Greenwood Place: App Ref. 2016/5372/P

HM Responses to comments received from Camden Council

HM has prepared this note to respond to feedback received from Camden Council on the energy strategy and approach to sustainability adopted by the scheme.

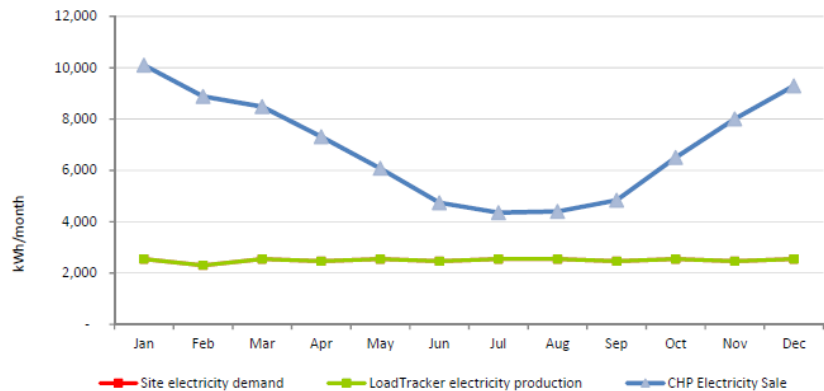
Camden Council comments (Email from Ana Lopez, dated 31.10.2016)	Applicant is proposing gas fired CHP which will be future proofed to enable connection to a decentralised energy network should one become available and should connection be considered viable at that point in time. This should be secured through the S106 (wording can be provided later). The system will be designed following recommendations set in the 'District Heating Manual for London' and an allowance will be made for indicative pipework routes and heat exchanger positions within the design. The CHP will be sized to meet hot water demands for the development but is also expected to meet the electrical demand from the commercial and residential common areas. Therefore solar PV is not considered compatible. A 40kWt gas-fired CHP (with backup boilers) is proposed. Sizing and required thermal storage are to be confirmed at the detailed design stage. This results in a 14.35% reduction at the 'Be Clean' stage of the energy hierarchy. Camden generally does not support the inclusion of small scale CHPs from a planning perspective because of the cumulative local air quality impacts and also because at this size they become uneconomical. Where CHP is proposed we ask applicants to provide justification and evidence to demonstrate that CHP is appropriate and has been appropriately sized for the development. The applicant has provided most of the detail below, it would be useful if they could provide the remainder.																																							
HM Response	1. Estimated annual and peak energy demands (kWh/year and kW) as follows: - Heat demand (for hot water and space heating separately) 94,642 kWh/annum (Space Heating) 170,101 kWh/annum (Hot Water) - Electricity demand (including unregulated energy) - monthly. Estimated landlord electricity demand is anticipated to be approximately 30,000 kWh/annum. This will be calculated at the detailed design stage. 2. Annual heat and electricity demand profiles.

Site electricity demand (as stated earlier) will be calculated at the detailed design stage and is estimated to be 30,000 kWh for the landlord areas.

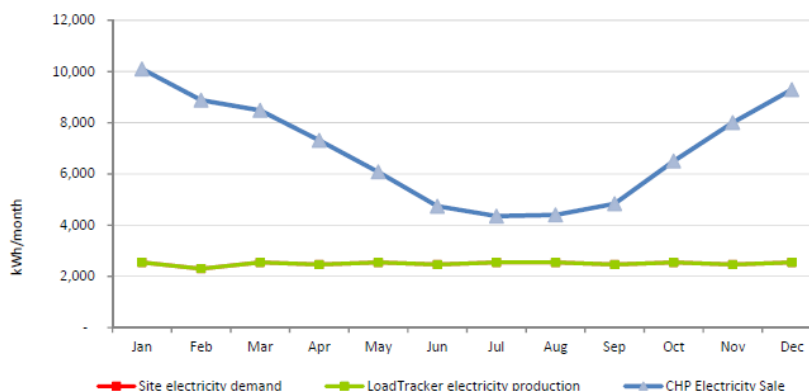
4. Proportion of the annual heat demand profile provided by CHP/boiler/other technology illustrated as a heat profile showing the

monthly demand profiles for heating, cooling and electrical loads alongside the CHP provision

The CHP is anticipated to meet 85% of the heating and hot water demand for the development. The CHP Load Tracker Units can maintain a similar profile to take into account typical seasonal variations in heat requirements, as shown below.
